Subject: Addendum 3, **Bid FB-26-05, Central Quad Remodel,
Las Posas Elementary School**

SLAB ADJACENT STRUCTURAL DOWEL SECTION
FB-26-05 CENTRAL QUAD REMODEL
LAS POSAS ELEMENTARY SCHOOL
75 E CALLE LA GUERRA, CAMARILLO, CA 93010

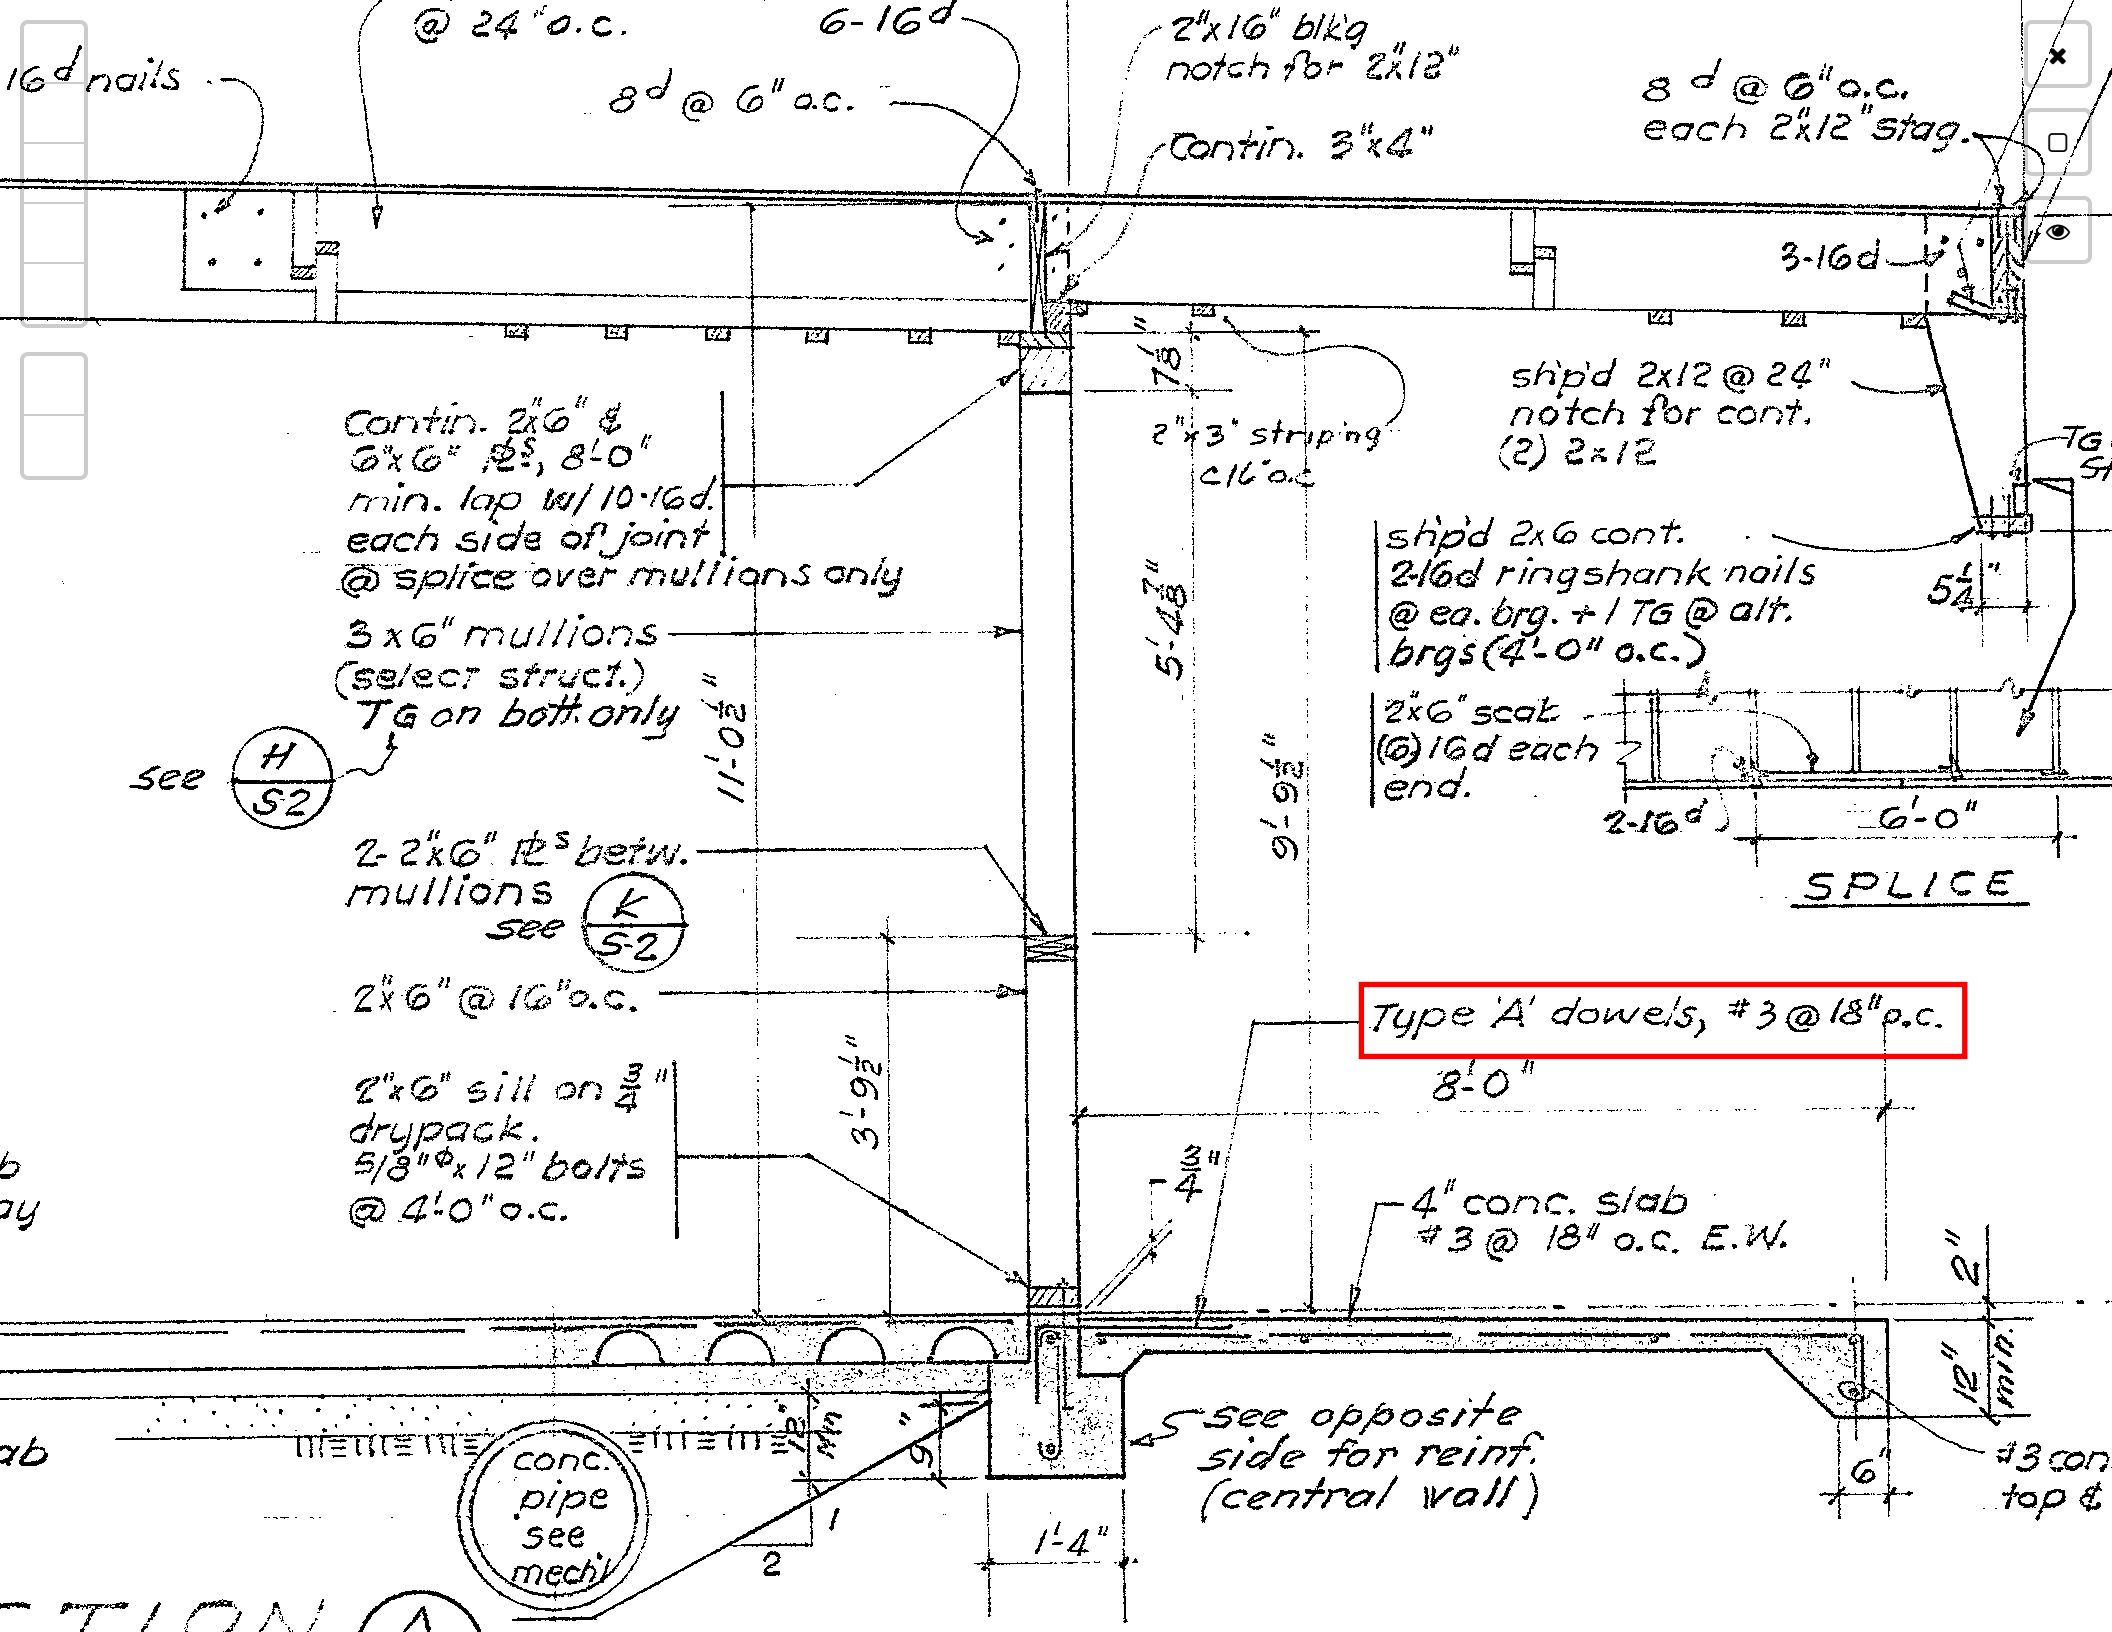
1. Answers the following submitted RFI:
Does the district know if the sidewalk that must be removed anchored to the building or should we put in an allowance for the stucco & painting for the building, if the sidewalk is anchored to the building?

Existing sidewalks have been determined to be dowelled to adjacent building, as depicted on the attached "LP Sidewalk Dowel" PDF.

Contractor shall demo existing sidewalk and cut dowel flush to building, while protecting existing structure in place. Damage to building shall be repaired in-kind at no additional cost to the District.
